# Shumaker Hall Shingle Roof Replacement Solicitation SAUT/25-26/01

## Questions and Answers

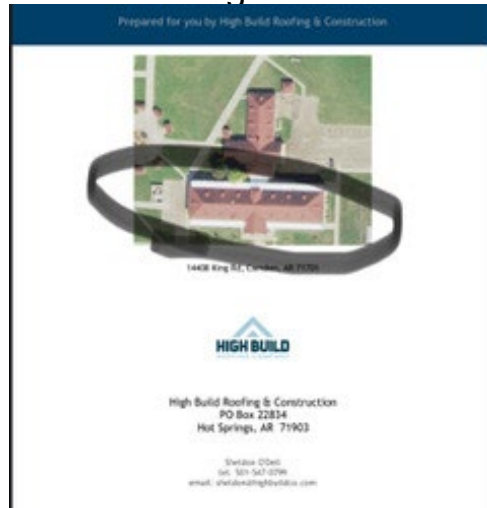
1. **QUESTION:** To clarify: Please see picture below and confirm if it is just the road side building or the building attached on the North side.

2. **QUESTION:** Also, the circled building has modified bitumen around the roofs outer edge on the North and South elevations. I want to confirm that this will also be replaced since the bid documents did not clarify this?

**ANSWER:** This project includes both buildings.

**ANSWER:** This project does not include modified bitumen around the roofs outer edge on the North and South elevations.
